ADDENDUM

Project: **Crestwood School District
Crestwood High School
Field Building & Site Improvements**

Project No.: **5622**

Addendum Number: **#1**

A9.03

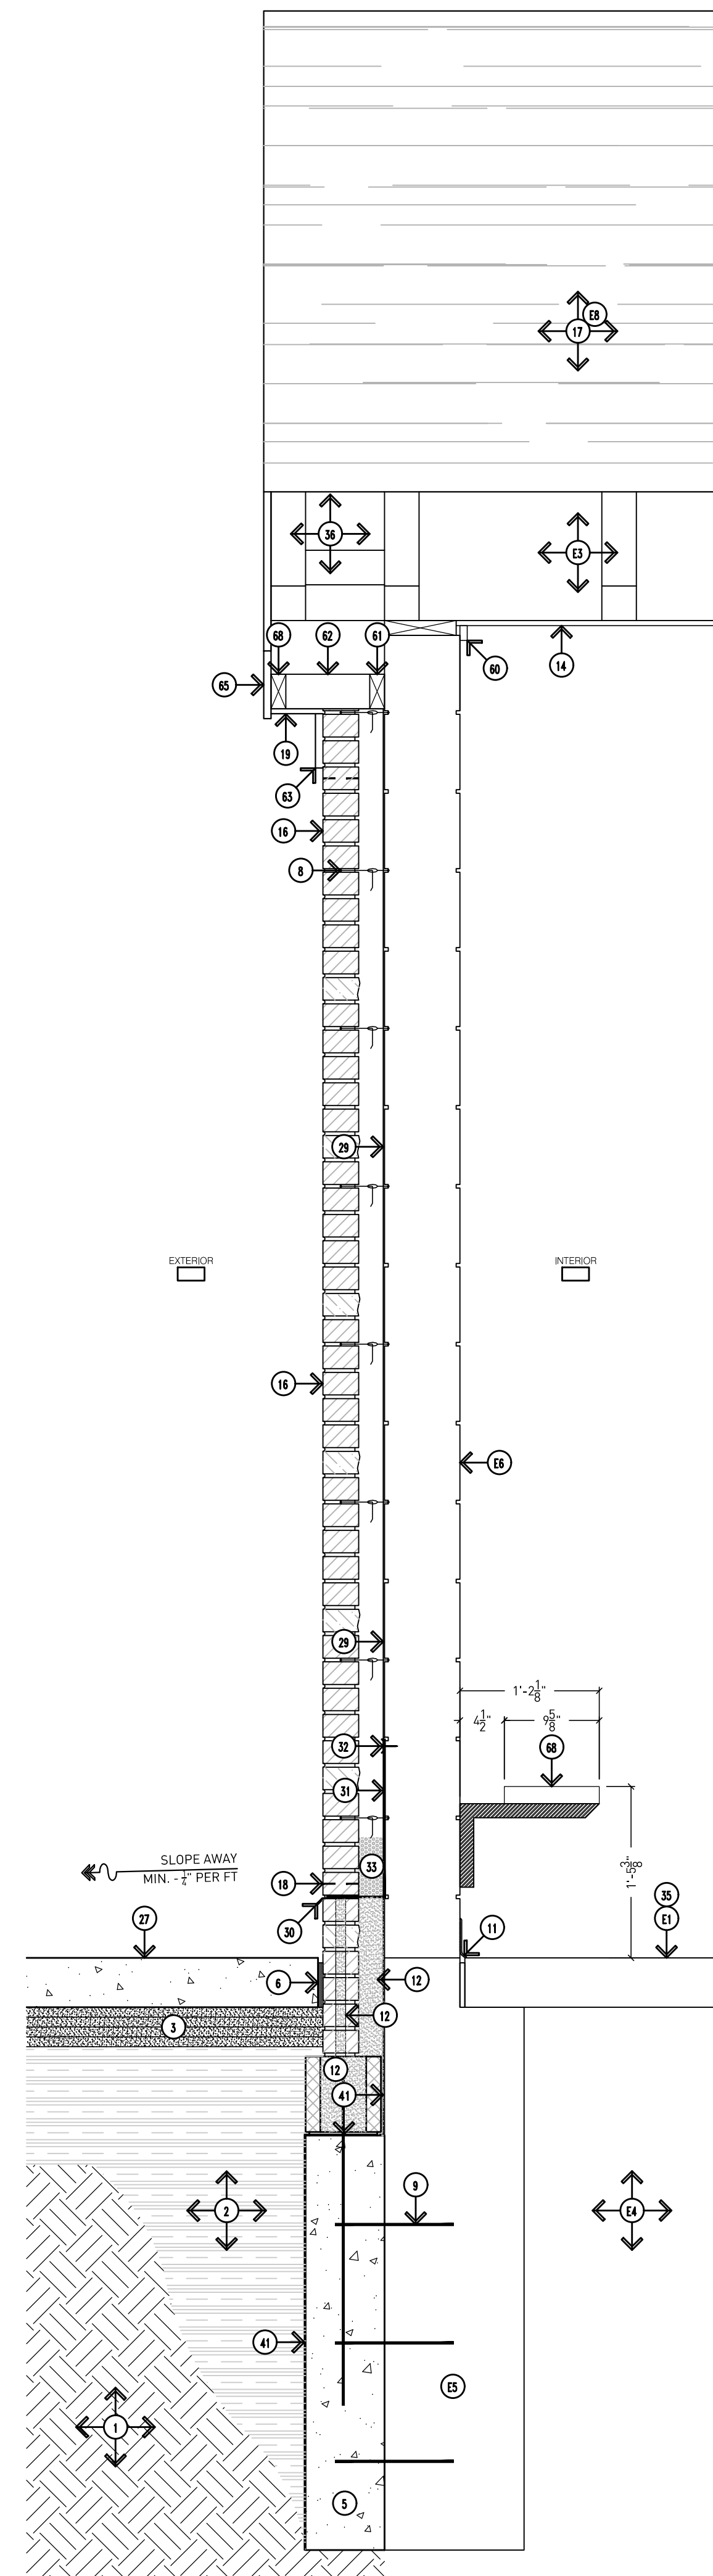
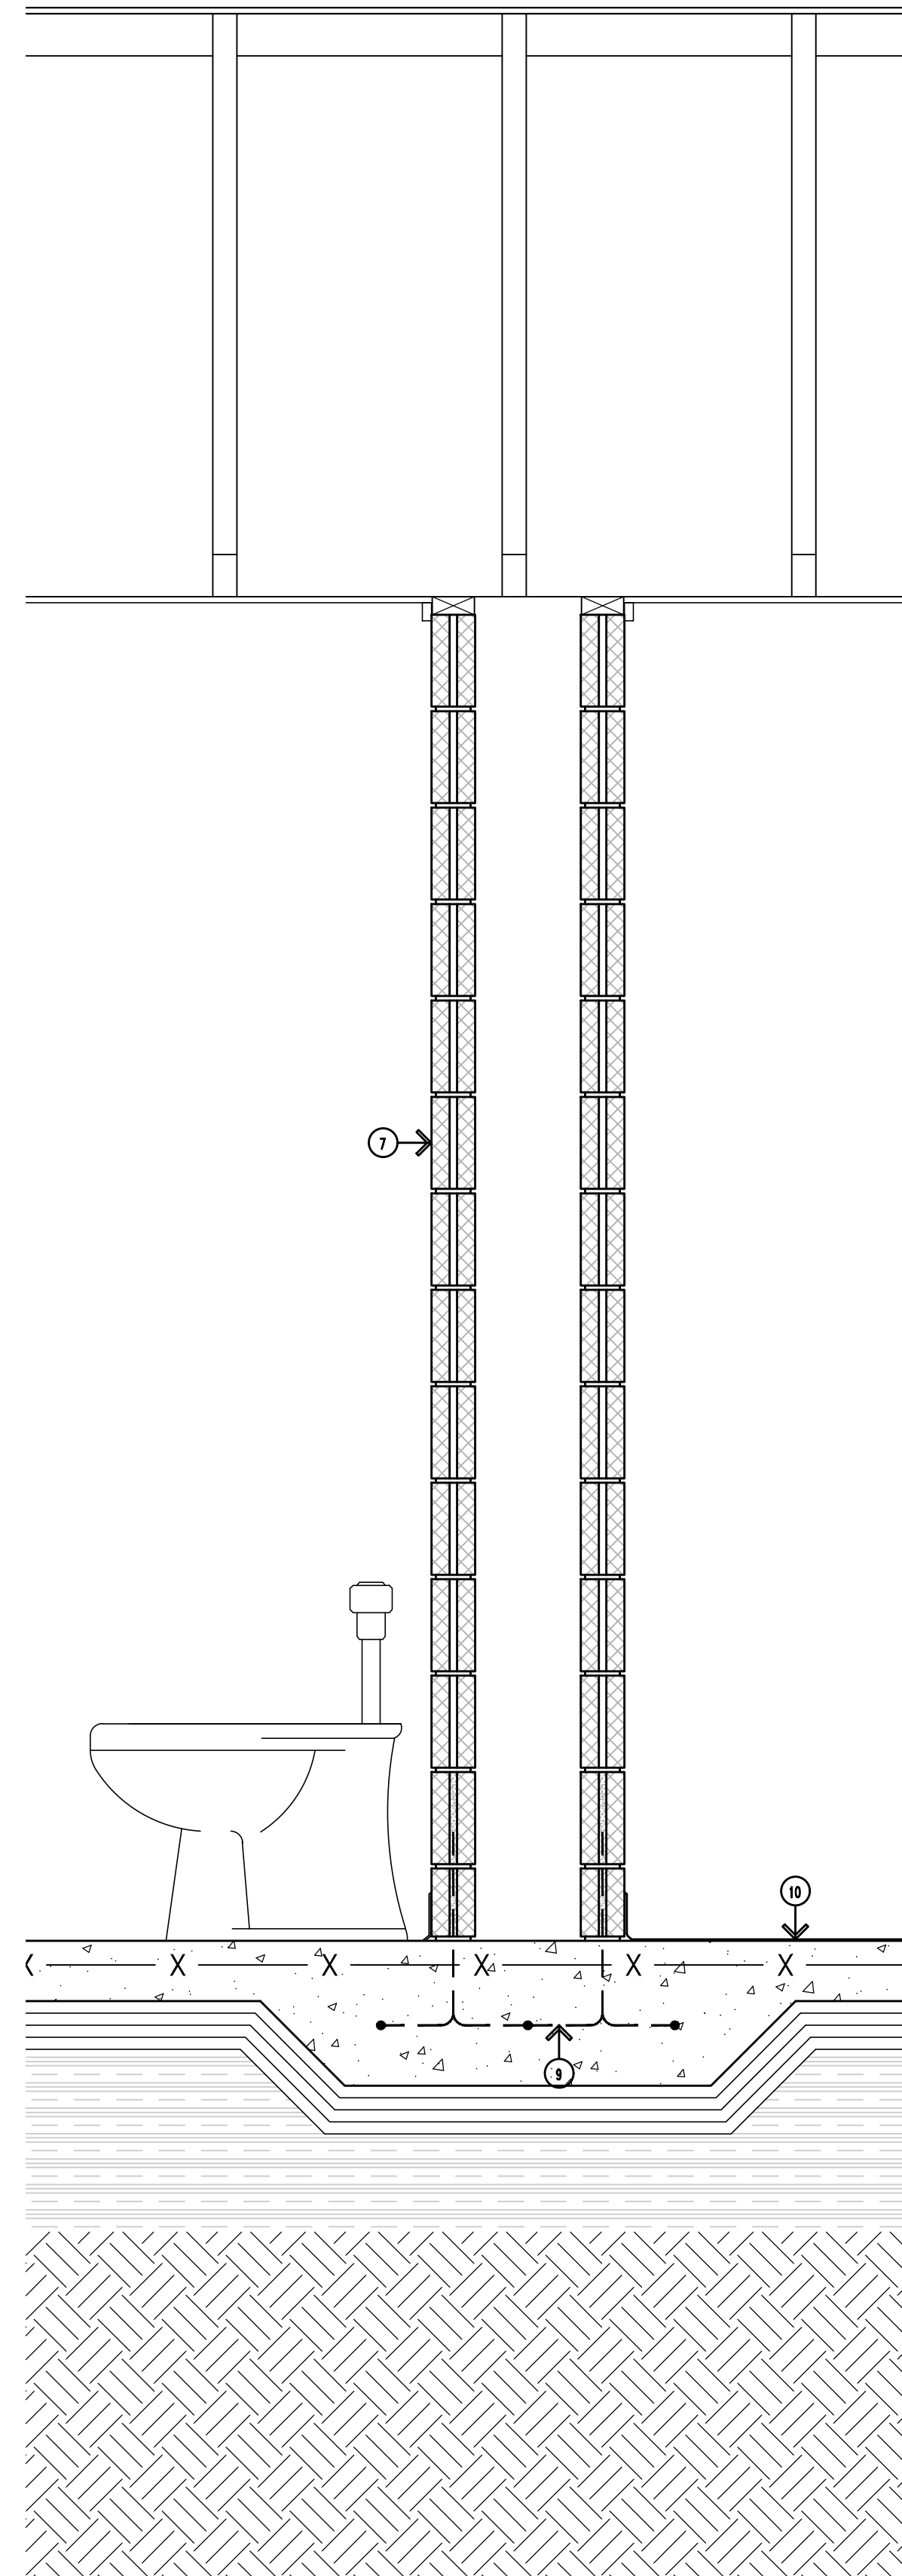
A9.03 – Exterior Wall Sections - Building B

CHANGE: Note 68

FROM: Heavy duty rated, steel framed wall mounted bench with aluminum seat.

TO: Heavy duty rated, steel framed wall mounted bench with aluminum seat, lengths to suit conditions - Pilot Rock; Product - WMB series.

A2 Building A: Area 1 Interior Wall Section
 Scale: 1"=1'-0"
 REFER TO 1/9.50 FOR TYPICAL NOTES

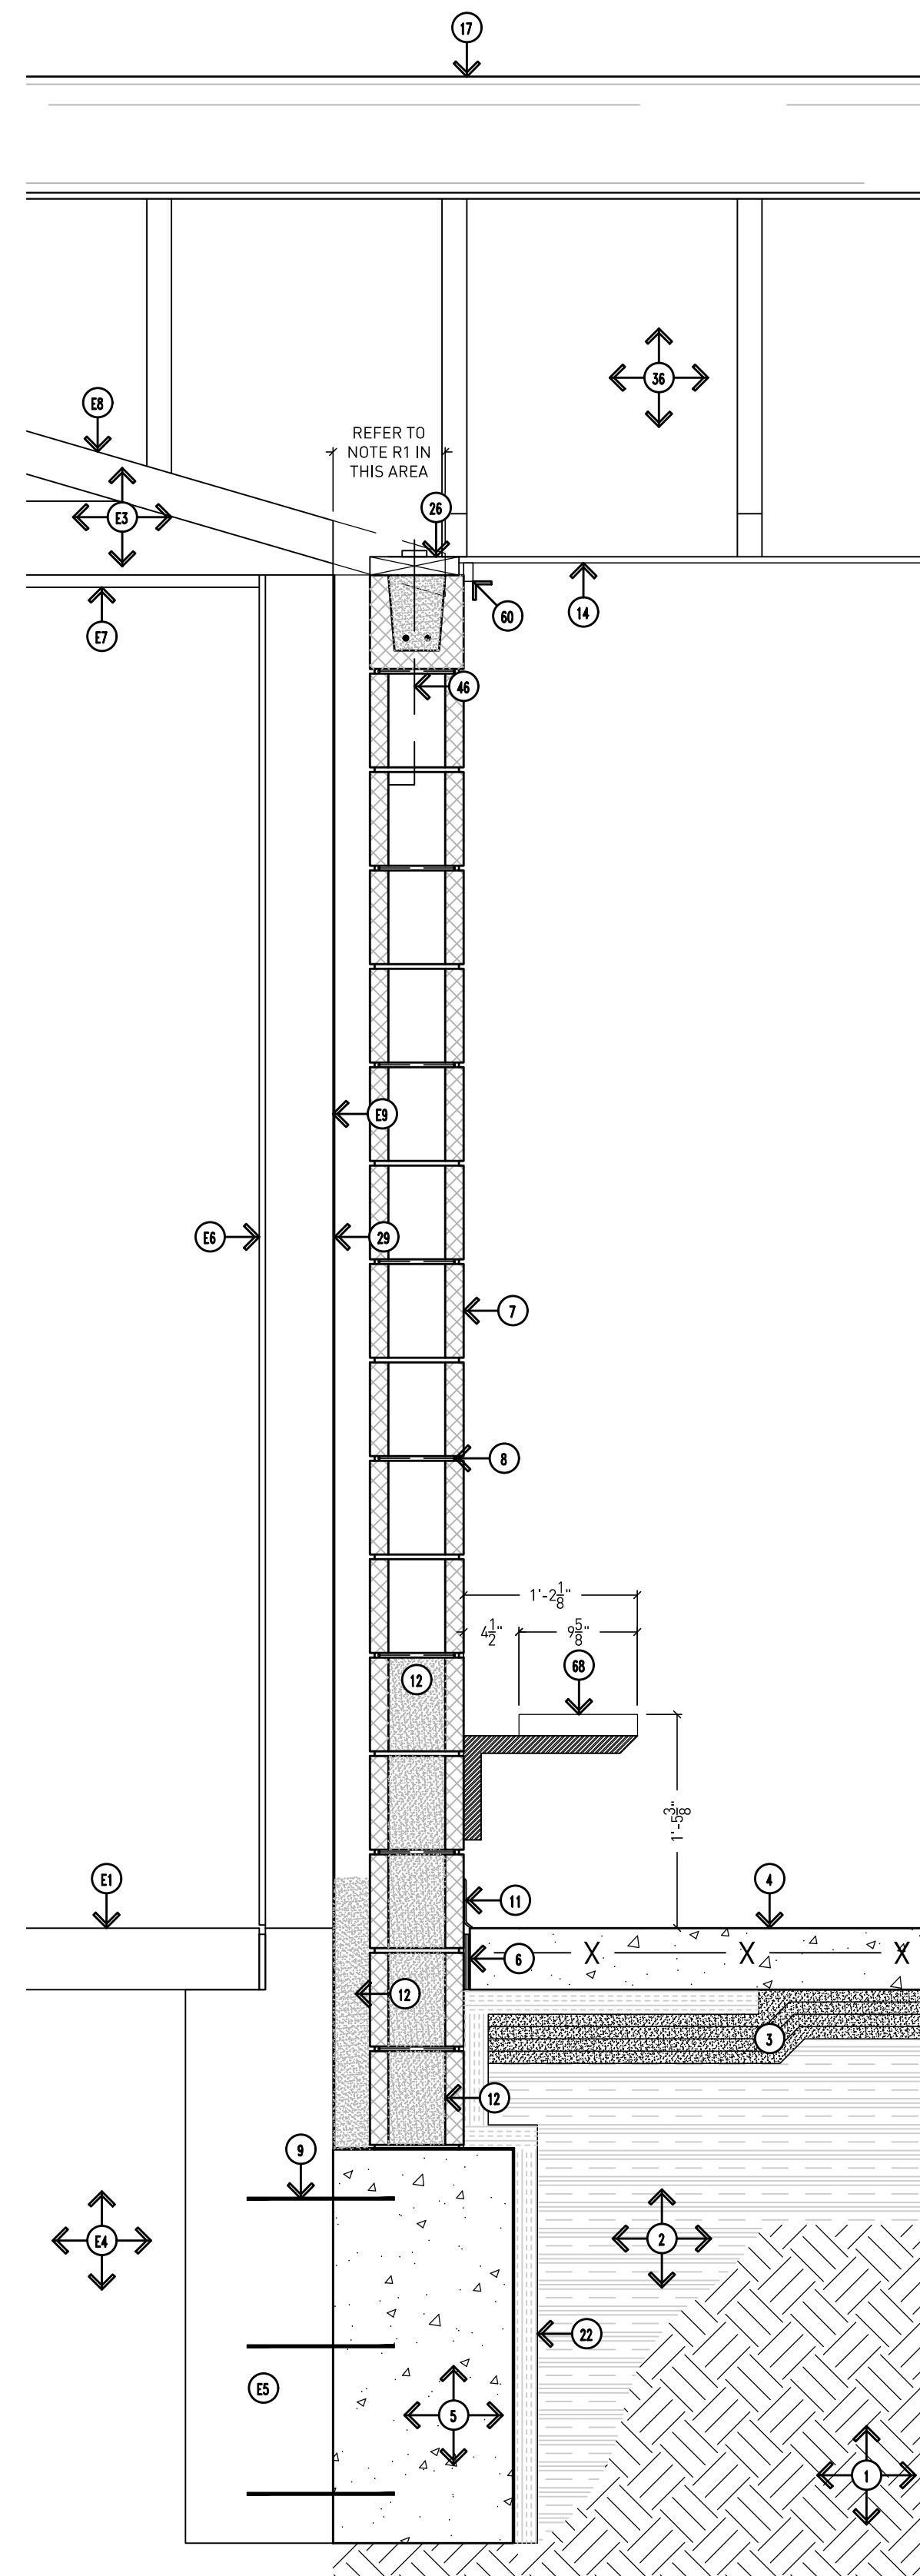
A9.50 – Interior Wall Sections

CHANGE: Note 68

FROM: Heavy duty rated, steel framed wall mounted bench with aluminum seat.

RFI Question 9: Is there a specification for the locker room benches?

TO: Heavy duty rated, steel framed wall mounted bench with aluminum seat, lengths to suit conditions - Pilot Rock; Product - WMB series.

RFI Answer 9: Refer to the attached updated sheet A9.50 note 74 for further information on specified product.
